(POWER BOARD)

Change note with Rev A

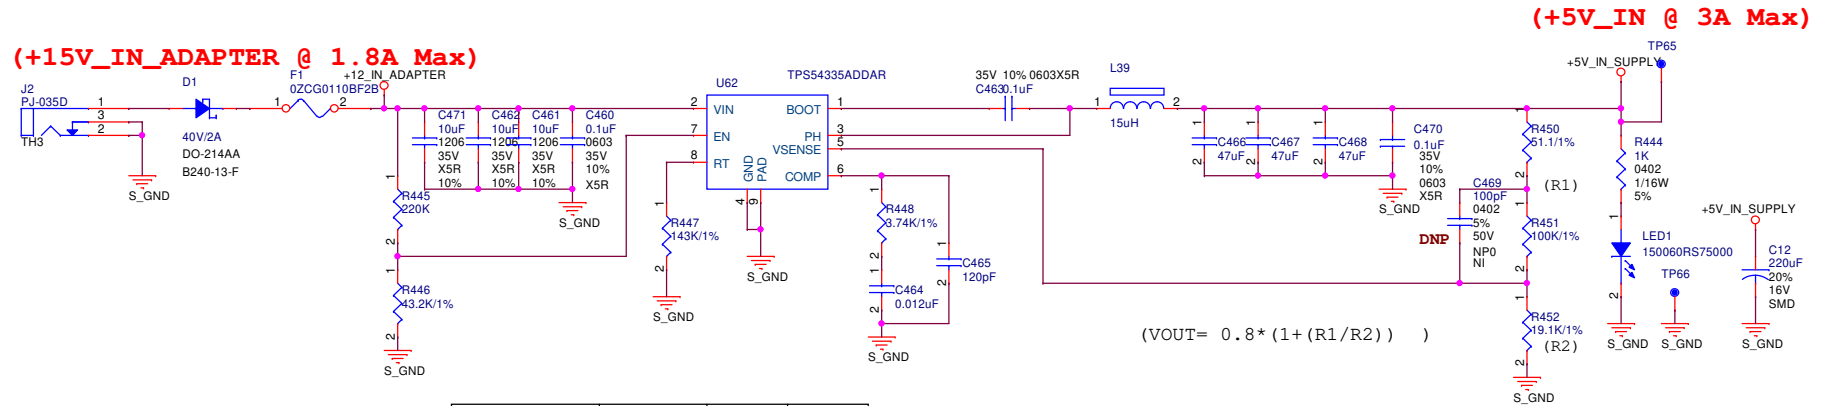
- 1- Remove 3.3 volt from main board, add 3.3volt LDO and 1.8 volt LDO
- 3- Swap net 5Volt at J48
- 4- Jack detection by hardware
- 5- J8 must change for big cable

6- Change FFC connector J48 for easy plugin??
